**Report: TAB Report**  
**Function: Test, Adjust, & Balance**  
**Date: 02/10/2026**  
**Completed By: National TAB**

**PROJECT**  
**02-02-26 QT #1403 PHOENIX, AZ**

QUIKTRIP  
4705 SOUTH 129TH EAST AVENUE  
TULSA, OK 74134

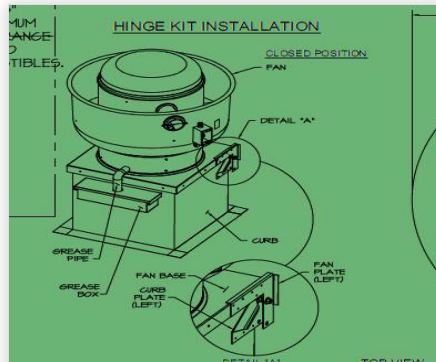
**Issue Name :** EF3 NOT PROPERLY INSTALLED  
**Description :** Hinge should be installed opposite of grease cup.  
**Created By :** National TAB                      **Assigned To :** National TAB - Dan Hertenstein  
**Status :** Open  
**Priority :** Low                                      **Asset Tag :** EF3  
**Originated Date :** 02/10/2026 - Christine Weale - National TAB

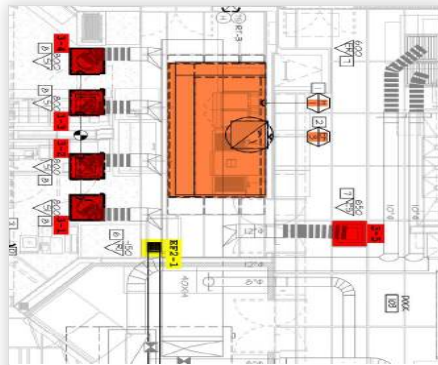
**Issue Name :** INACCESSIBLE DAMPER  
**Description :** Duct is not routed per GRD, it goes somewhere into the kitchen, therefore the damper is inaccessible (no tiles to remove).  
**Created By :** National TAB                      **Assigned To :** National TAB - Dan Hertenstein  
**Status :** Open  
**Priority :** Low                                      **Asset Tag :** SGRD5  
**Originated Date :** 02/10/2026 - Christine Weale - National TAB

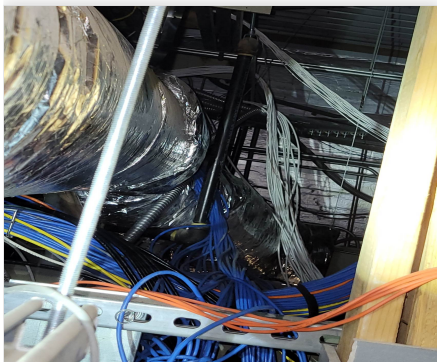
**Issue Name :** KINKED/RESTRICTED DUCT  
**Description :** SGRD1-13 Flow varies between -40 and 40cfm; which means low flow is due to restricted duct (lots of turbulence). Picture shows either wires or duct placed to the wrong side. Duct should be moved to the right of the wires to avoid kinks. High priority due to how hot it is in the electrical room.  
**Created By :** National TAB                      **Assigned To :** National TAB - Dan Hertenstein  
**Status :** Open  
**Priority :** High                                      **Asset Tag :** SGRD13  
**Originated Date :** 02/03/2026 - Christine Weale - National TAB
